**STAFF REPORT 02/17/2021 MEETING**

**APPLICATION NUMBER: #21-7098**

**ADDRESS: 4221 CASS (STUBER AND STONE BUILDING)**

**SCOPE: REPLACE WINDOW AT NORTH/SIDE ELEVATION, SECOND STORY; REPLACE CONCRETE LINTELS**

4221-4229 Cass, **NORTH ELEVATION**, current elevation. The current windows at Units #300 and #400 are at this location

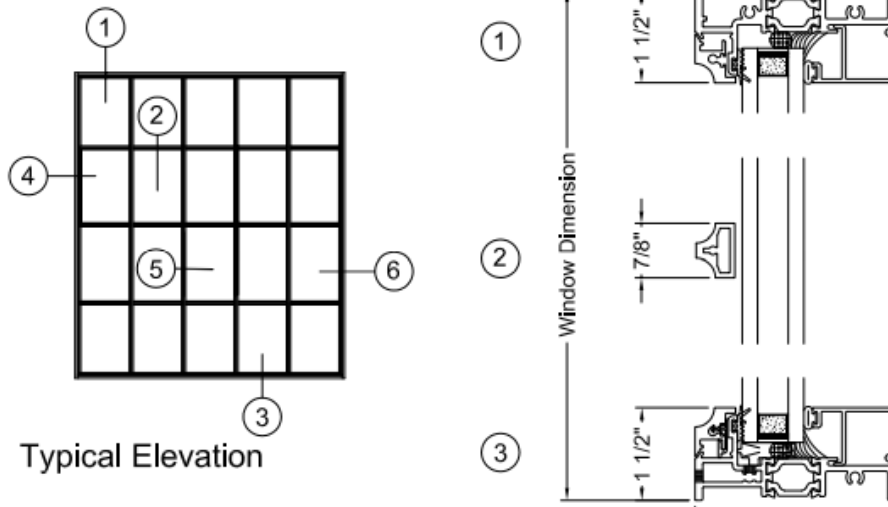
- Per the above photo, the current second-story, north elevation window opening and accompanying aluminum sash at Unit #300 were added during the 1990s rehabilitation

- A review of the 1996 photo revealed that the design/lite configuration of the current second-story, north elevation window at Unit #300 closely matches the building's historic windows

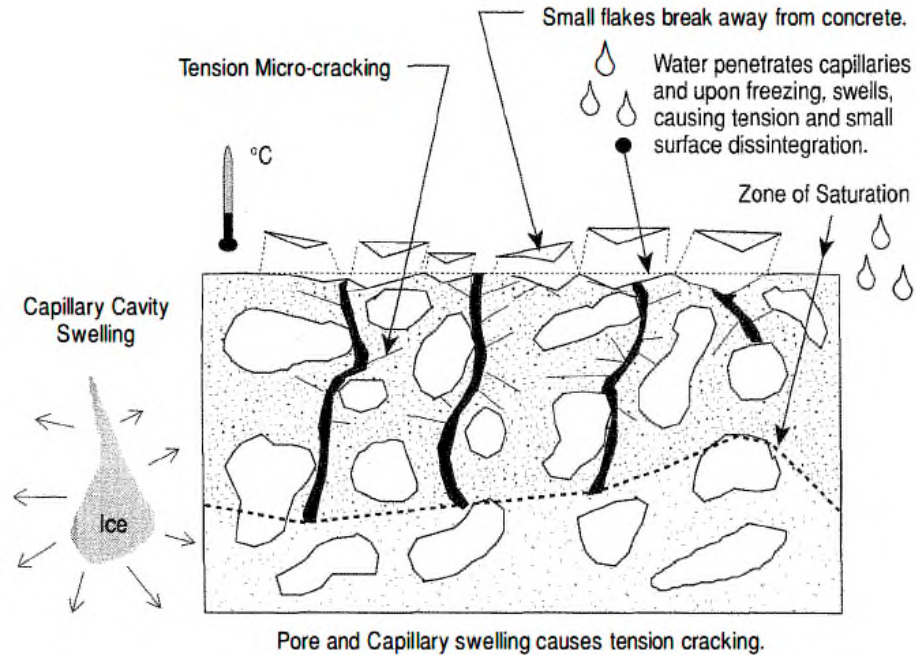
Unit #300 was visually inspected from the interior and hammer sounded from the exterior. During the survey, we noted severe deterioration at the entire bottom of the beam (above the window), with moderate damage observed at the surrounding concrete members (beam below window and adjacent column 300/400). This includes widespread cracking and spalling concrete. Large crack separation at bottom of beam. No steel reinforcement was visible but it should be assumed that the crack has developed from steel corrosion and a structural repair is required. Pullman recommends fixing these areas to eliminate falling debris hazards (both inside and outside) and the potential for growth of the deteriorated areas.

Unit #400 was visually inspected from the interior and hammer sounded from the exterior. During the survey, we noted severe deterioration at majority of the bottom of the beam (above the window). Large crack separation at bottom of beam. No steel reinforcement was visible but it should be assumed that the crack has developed from steel corrosion and a structural repair is required. Pullman recommends fixing these areas to eliminate falling debris hazards (both inside and outside) and the potential for growth of the deteriorated areas.

Photo No. 12 – Exterior Unit 700

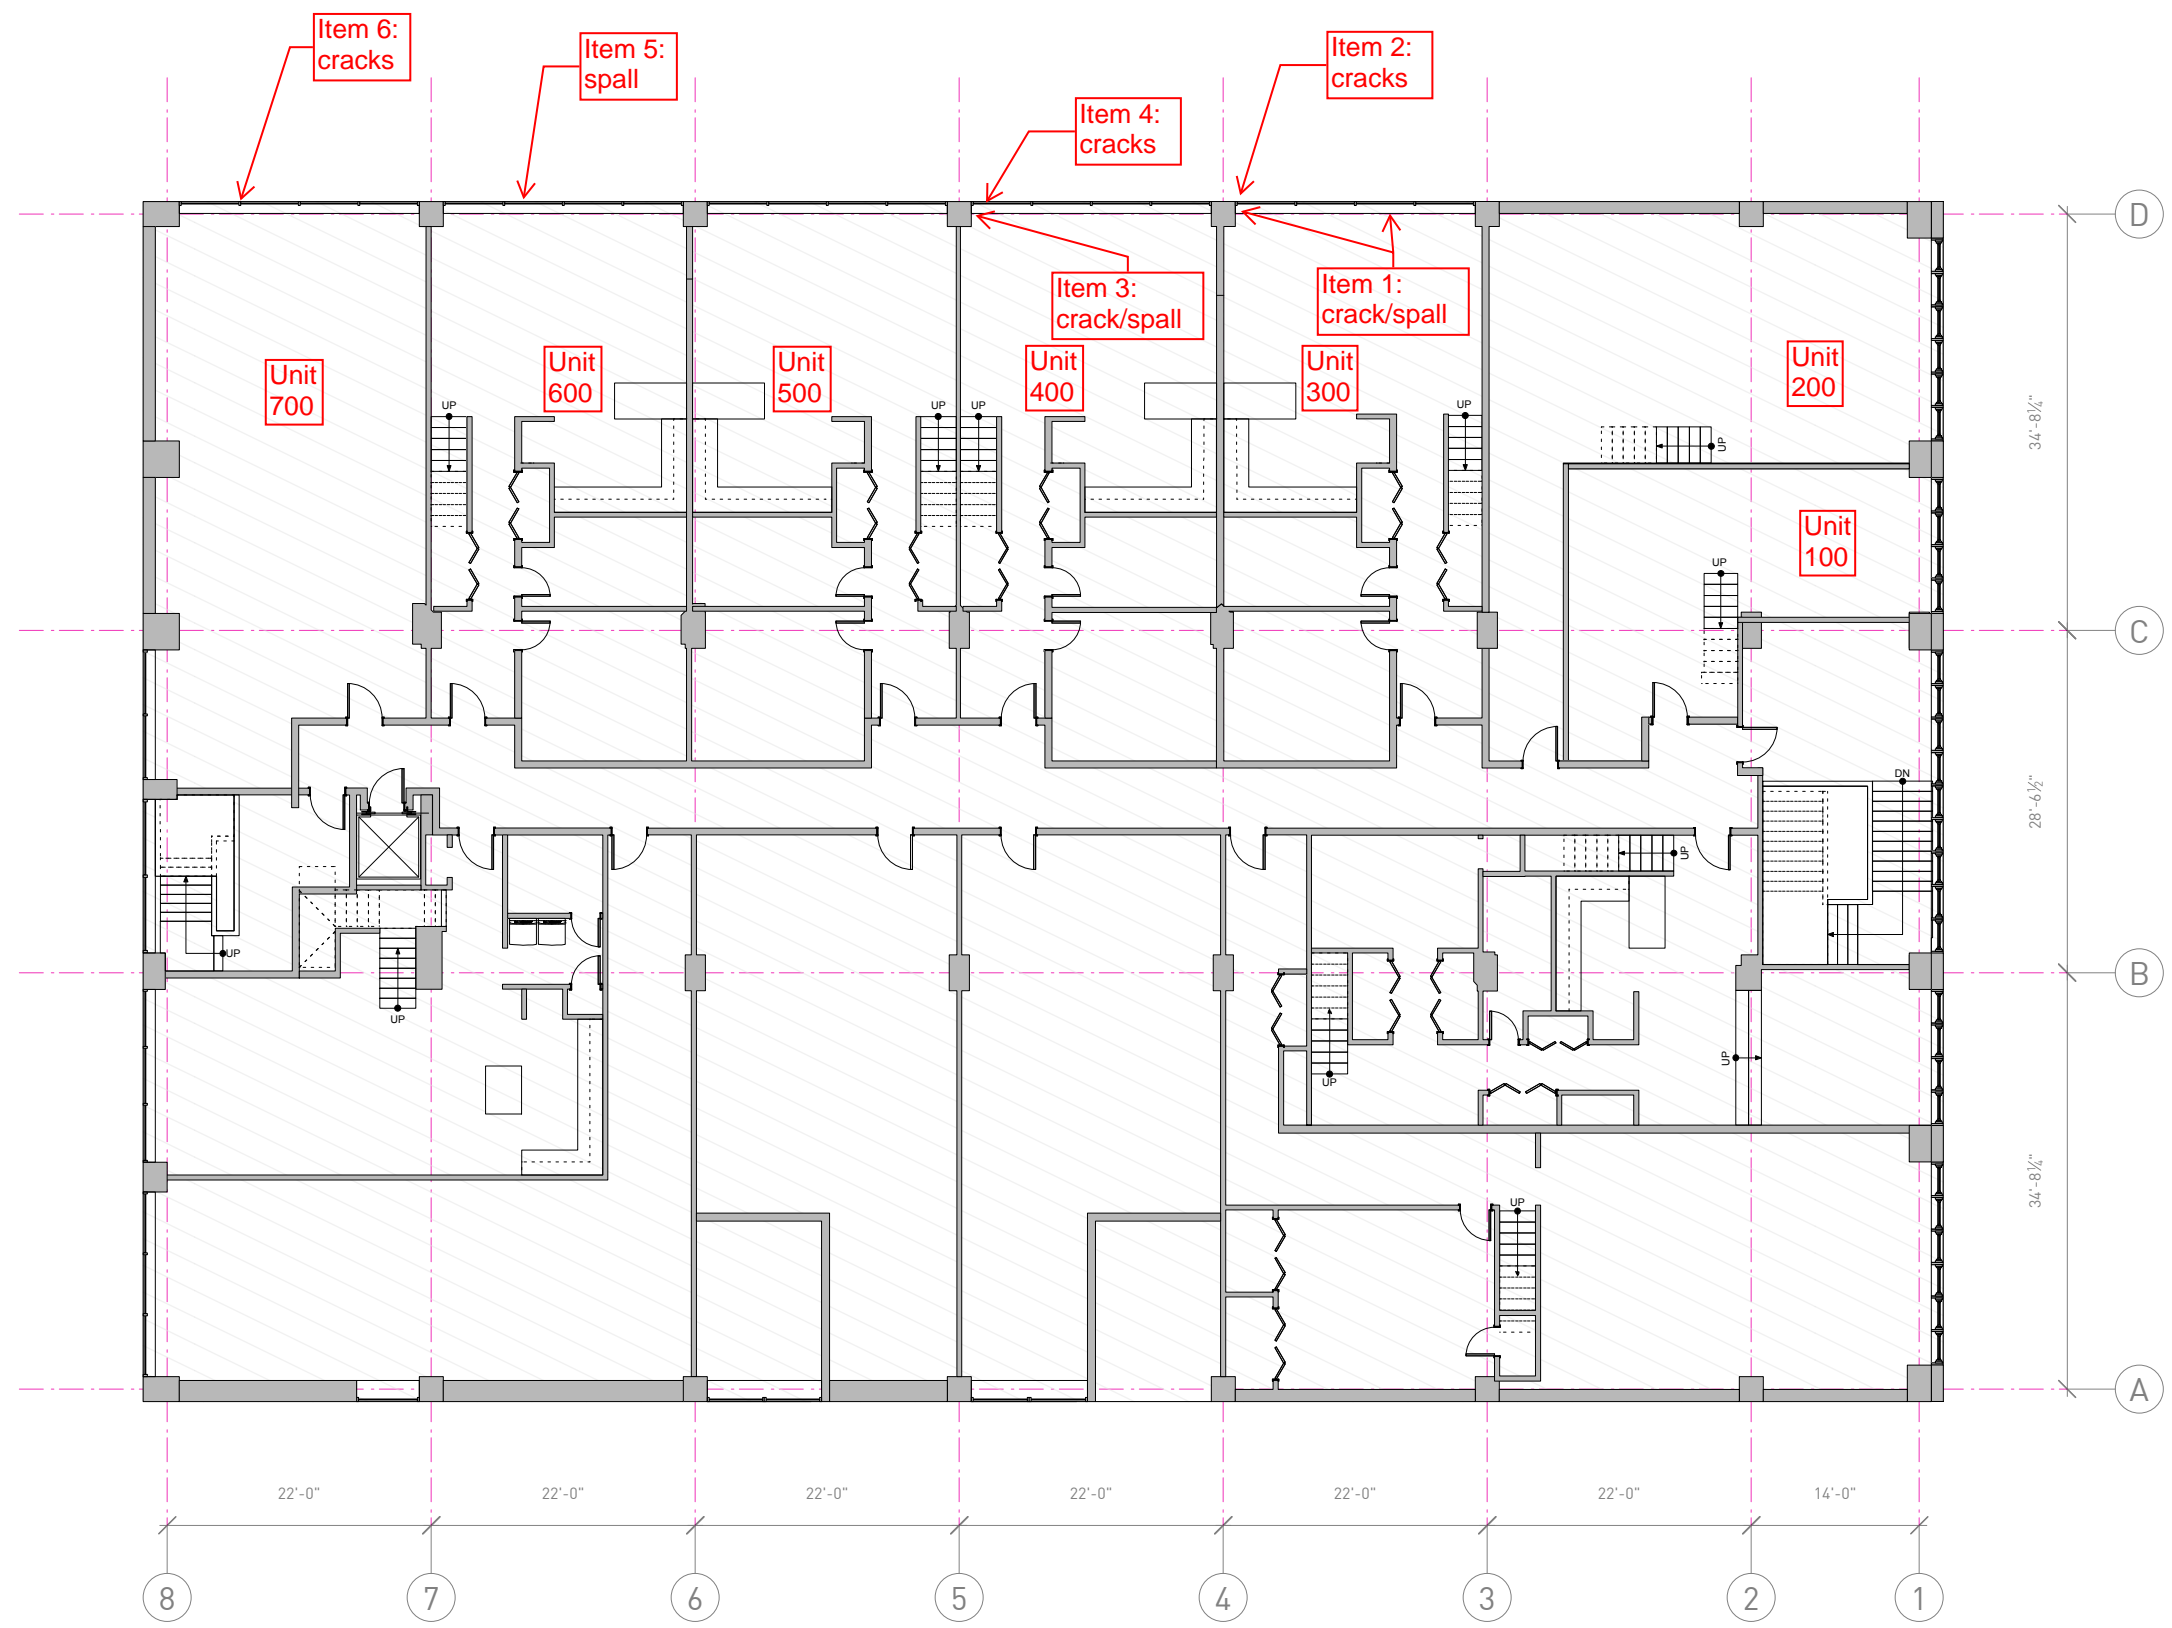
Item No. 6: On the exterior of the building, for the beam above the windows, there are cracks that appear to have been previously repaired by just filling them with joint sealant. Refer to Photo 12.

Suggested repair: Route out cracks. Inject with structural crack repair (SIKADUR 35 HI-MOD LV, Cap seal with SIKADUR HI-MOD GEL). If concrete is delaminated, Remove delaminated concrete, clean corroded reinforcing steel. The reinforcing steel will need to be evaluated for section loss to determine if additional reinforcement is required. Apply SIKA Armatec 110 EpoCem to resteel. Replace removed concrete with repair mortar (Xypex MEGA MIX II, hand applied). Shoring may be required.
